Detailed Site Plan

9395 Lanham Dunkin

DSP-23034

STAFF REPORT

ELEVATIONS

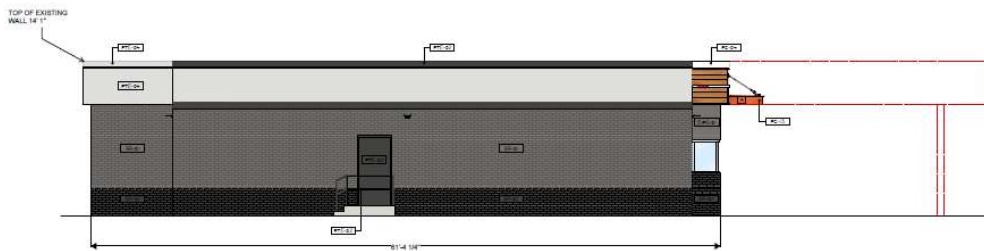
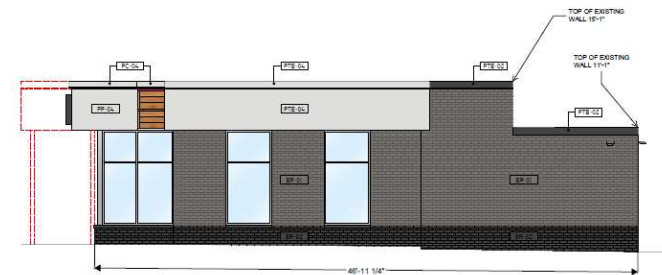
1. Drive aisle for one-way traffic should be at least 11-feet wide.
2. The front elevation on Sheet 5 and Sheet 7 are different regarding the proposed signage design.
3. Street connection width should be shown on the plans.
4. Height of existing building should be provided on site plan (Sheet 3).
5. The Permit Review Section offers no further comments at this time.
